# **CENTRAL LAND COUNCIL**

**Submission to the Water Resources Division,  
Northern Territory Department of Lands, Planning and  
Environment**

**Draft Alice Springs Water Allocation Plan 2026-2036**

## HYDROGEOLOGICAL REVIEW OF THE DRAFT ALICE SPRINGS WATER ALLOCATION PLAN 2026-2036.

Figure 1: Location of Alice Springs water plan management zones (Water Assessment Report 2025 Pg 46). Suggested approximate priority dual/nested monitoring bores areas are marked with red shapes.

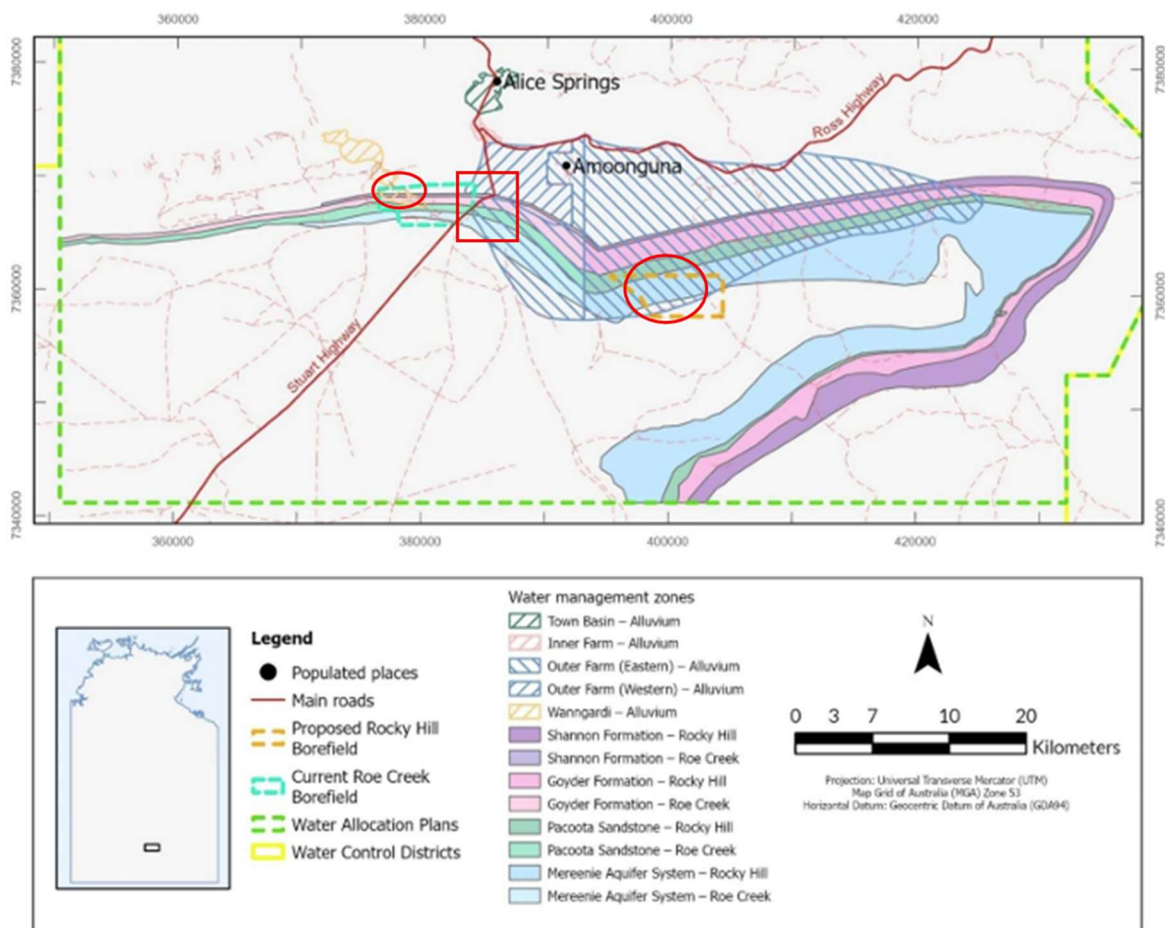
Suggested approximate priority dual/nested monitoring bores areas are marked with red on Figure 1 below. From Table 2 it appears the Rocky Hill and Roe Creek zones do not have any alluvial groundwater monitoring bores. This lack of monitoring of the alluvial aquifer is a significant gap in these areas as well as around high value GDEs. It is unclear from our review of the selected documents where the dual/nested monitoring bores that exist in the groundwater monitoring network are located.

As mentioned above the vertical connectivity between aquifers and the surface is not well characterised and dual/nested monitoring bores (e.g. deep and shallow bore at the same site) need to be installed in these locations so vertical connectivity and recharge/discharge can be better estimated and subsequently modelled. Cultural water sites are poorly monitored and from our review it doesn't appear any are part of the monitoring requirements; implementation actions related to this are scheduled to be delivered between 2030-2033 but the system is overallocated under the current plan (2016-2026) and allocation is proposed to be increased. CLC should consider documenting the cultural values in the plan area that are at risk.
